From: David King <[REDACTED]>
Sent: Monday, October 20, 2014 3:16 PM
To: Guernsey, Greg
Cc: Camou, Juan; gardner sumner
Subject: 2015 Goodrich Avenue - Appeal Issuance of Building Permit - 2014-093888 PR
Attachments: 2015 Goodrich Avenue - Appeal.pdf; 2015 Goodrich appeal reasons.doc

2015 Goodrich Ave (Permit Number 2014-093888 PR)

Planning and Development Review Department interpretation is: Re: 2014-093888 PR

FROM: Daniel Word, Planner Principal, Residential Review

ORIGINAL SURVEY
SCALE: 1"=20'

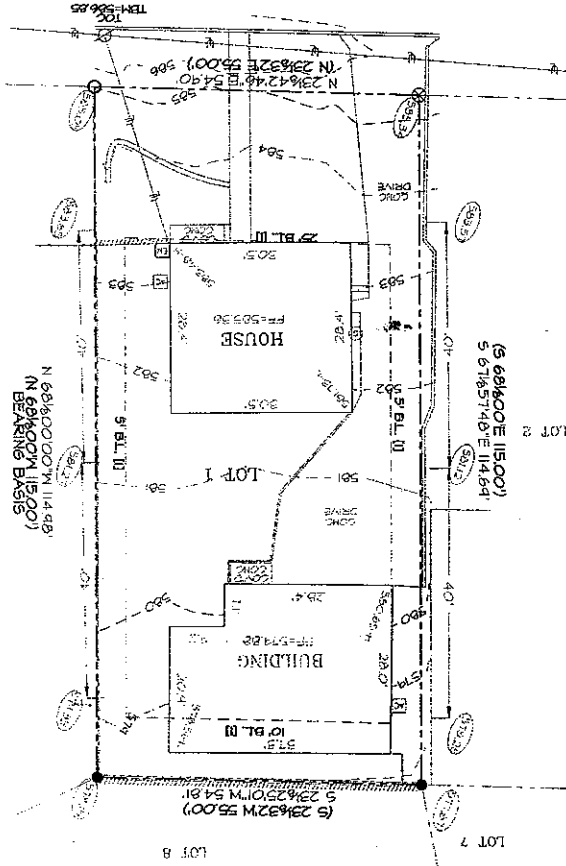
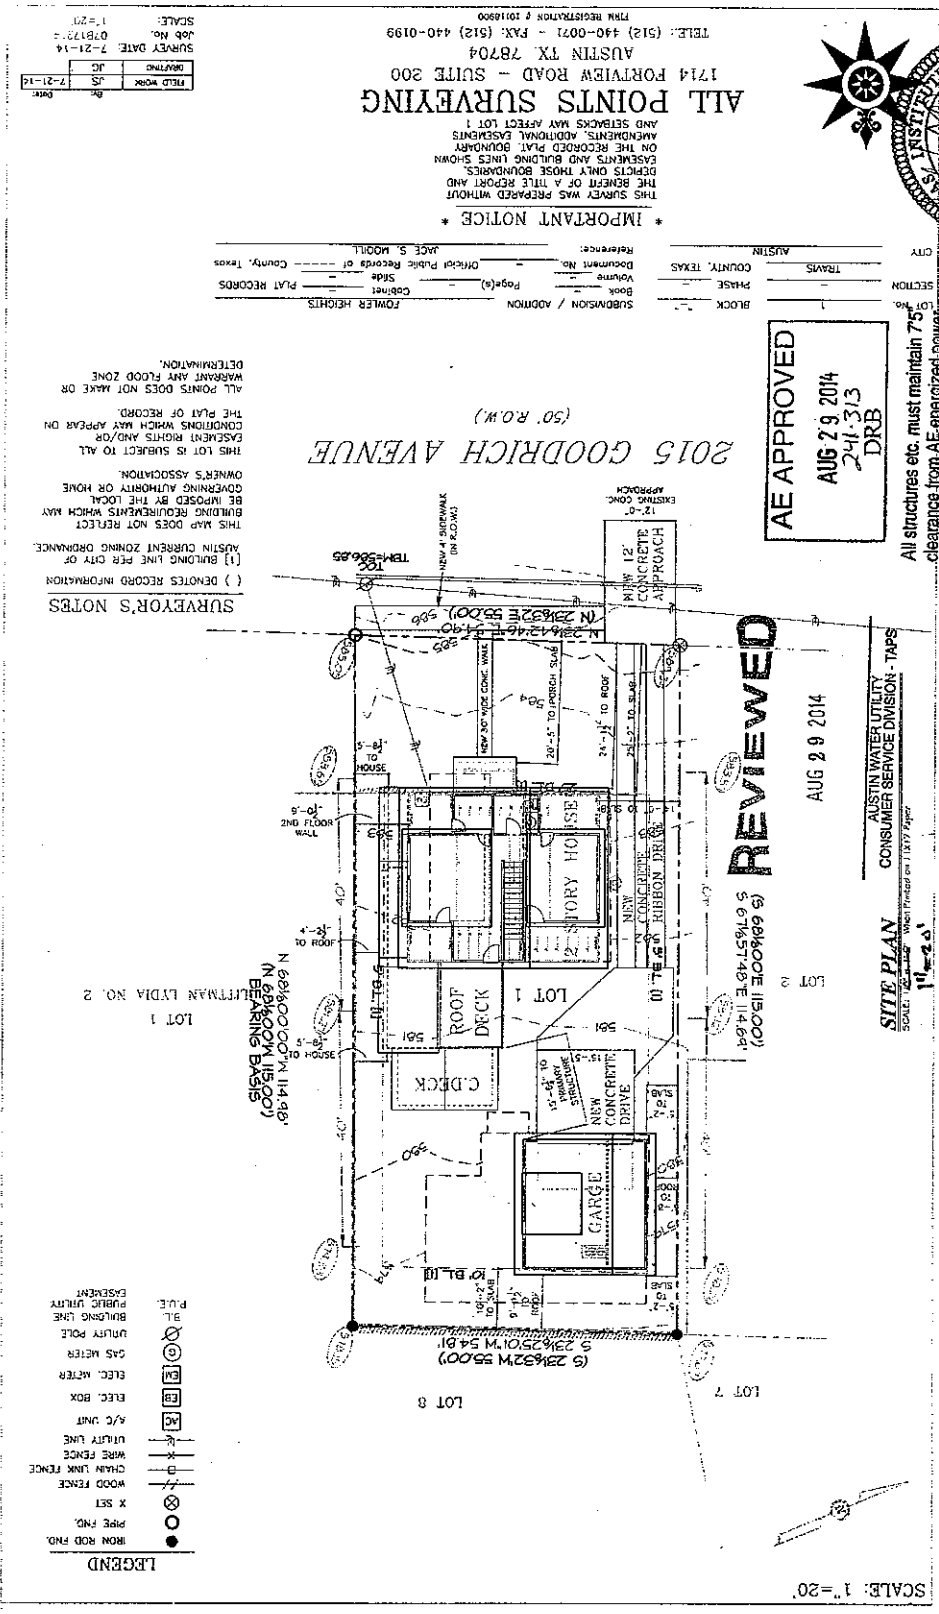
- 1) The applicant is using a lot size of 6,325 sq ft to make impervious cover and McMansion FAR calculations. This is the lot size shown at the Travis County Appraisal District (TCAD). However, the applicant presented an actual survey conducted by All Points Surveying on 21 Jul 2014. The property lines shown on this survey calculate to 6,296.6 sf. The surveyed area should be used since the TCAD areas are notoriously inaccurate. This will result in a higher impervious cover and McMansion FAR percentage.

1244 SQ. FT. LIVING
2nd FLOOR PLAN
SCALE: 1/4" = 1'-0" When Printed on 24X36 Paper
SCALE: 1/8" = 1'-0" When Printed on 11X17 Paper

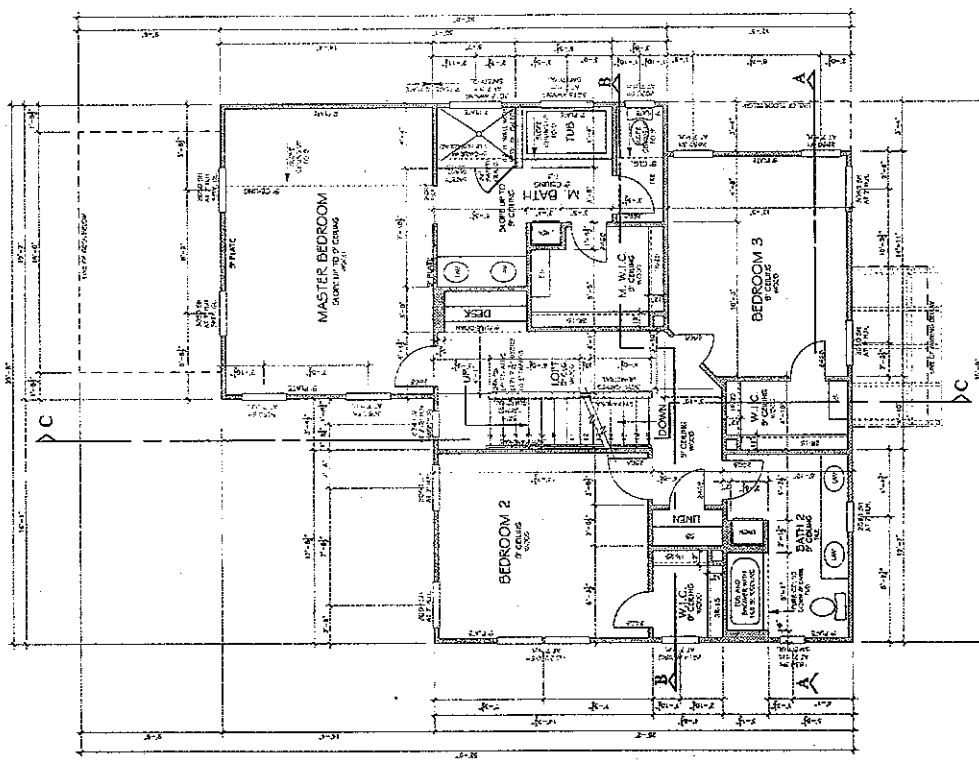
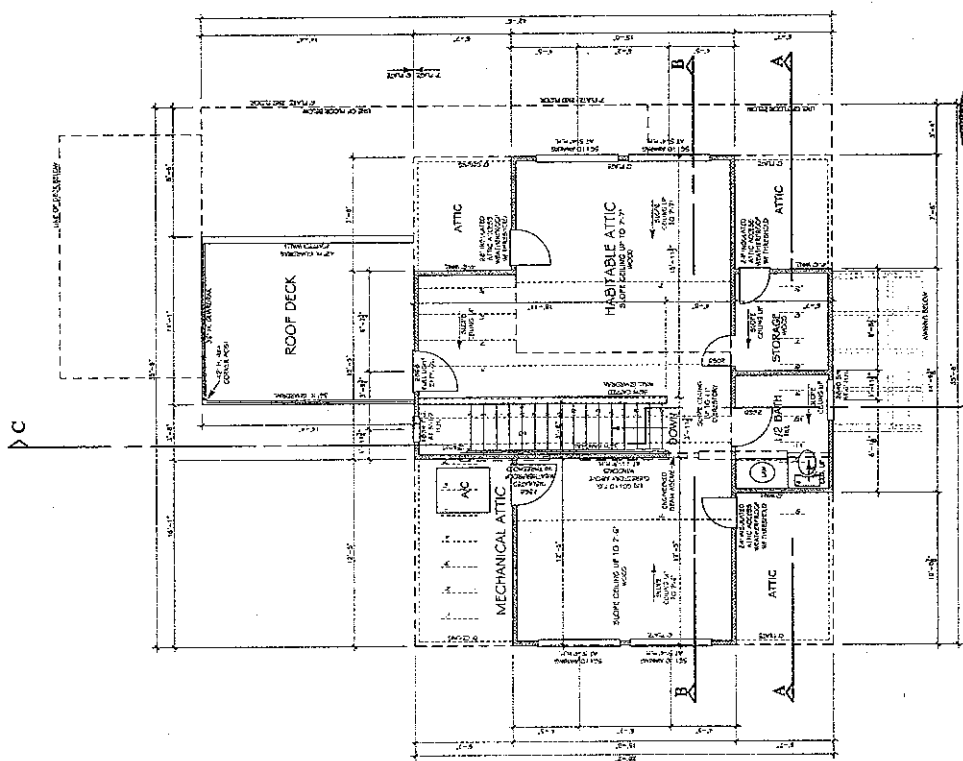
- 2) The architectural plans of the first and second floor (Drawings A1.1 and A1.2) appear to be drawn to the outer edge of the wood framing and not to the "outside surface of the exterior walls" demonstrated by the fact that the first floor plan dimensions (Drawing A1.1) match the foundation plan dimensions (Drawing S-1). Normally, the edge of the framing is aligned with the foundation edge. When sheathing and siding is added, this dimension can increase by an inch or more on all sides. Since the criteria for calculating the McMansion FAR is measurement to the "outside surface of the exterior walls", the McMansion FAR is not calculated correctly. If one assumes a ½" sheathing and ¾" siding, the first floor area is increased to 1,301.6 sf and the second floor area is increased to 1285.3 sf. This is an additional 33.8 sf that must be added to the McMansion FAR calculation.

656 SQ. FT. LIVING AT 5' + CEILING HEIGHT
664 SQ. FT. AT 4'-0" WALLS
HABITABLE ATTIC PLAN
SCALE: 1/4" = 1'-0" When Printed on 24X36 Paper
SCALE: 1/8" = 1'-0" When Printed on 11X17 Paper

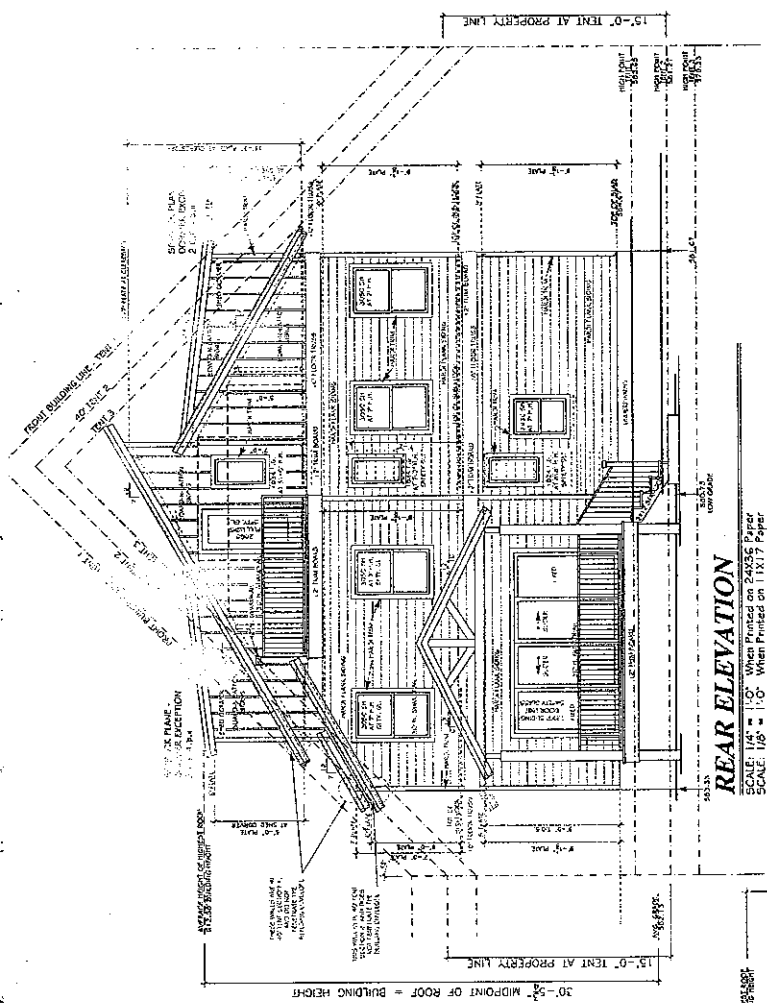
1. The dormers are not fully contained within the roof structure contrary to requirement #2. We believe the dormers are exactly what requirement #2 was specifically intended to prevent. It is hard to envision any other purpose of this provision. While there is a "dormer exception" from the setback plane as described in Section 2.6.E.4.b.ii of Subchapter F (Residential Design and Compatibility Standards), this exception is specifically related to the "Setback Planes" defined in Section 2.6, not to the "Gross Floor Area" defined in Section 3.3.

2. The dormers add additional mass to the structure contrary to requirement #5. In addition, the vertical wall with windows facing the side street which separates the two primary roof slopes also adds mass. If it weren't for that wall, the two slopes would meet at a peak much lower than the proposed peak, and the mass of the roof structure would be less.

3. The third floor deck (called a "roof deck" in the habitable attic plans) is accessible from the "habitable attic". While the deck itself would not be subject to McMansion FAR, the fact that it exists supports our contention that the habitable attic is actually a third floor rather than a fully contained attic.

The attic exemption should be disallowed and the applicant should recalculate the McMansion FAR as if this area is a third floor.

Fig 1

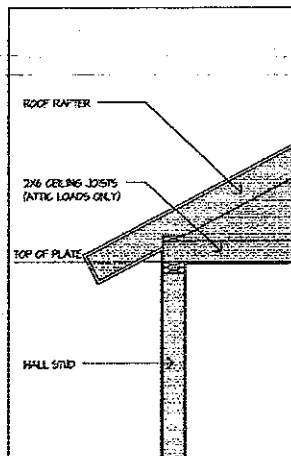
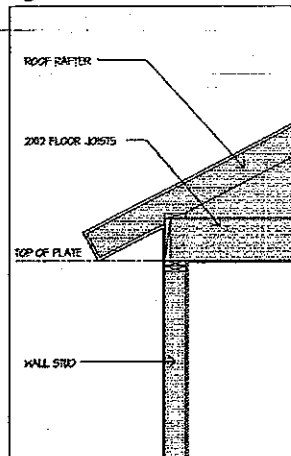
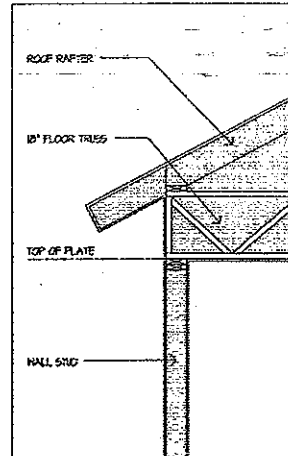
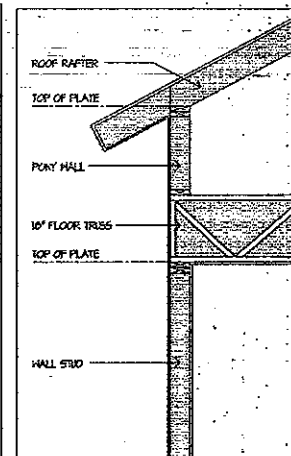
Figures 1, 2, and 3 are examples of acceptable construction methods that would qualify as being "fully contained within the roof structure." Figure 4 is a sketch of an unacceptable construction method for the purpose of qualifying as being "fully contained within the roof structure." This attic area would not qualify for exclusion from the calculation of gross floor area.
